Consultation Response from KC,

Highways Development Management

2024/91316 Clough House, 236, Leeds Road, Birstall, Batley, WF17 0HW

Conversion of existing dwelling and outbuilding to create 6 apartments and erection of 17 dwellings

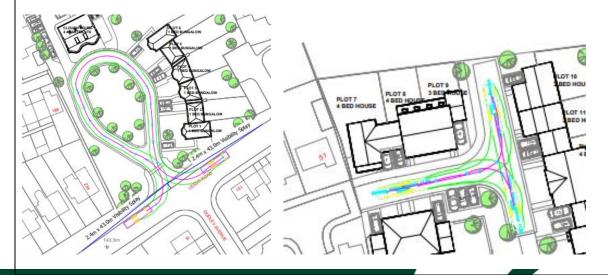
Kirklees require a swept path analysis for an 11.85m in length refuse vehicle indicating how it can pass an on-coming or parked family car throughout the layout. The carriageway will require widening on the bends to enable this manoeuvre. The current proposal does not enable the refuge vehicle to pass an on-coming or parked car, please amend and resolve.
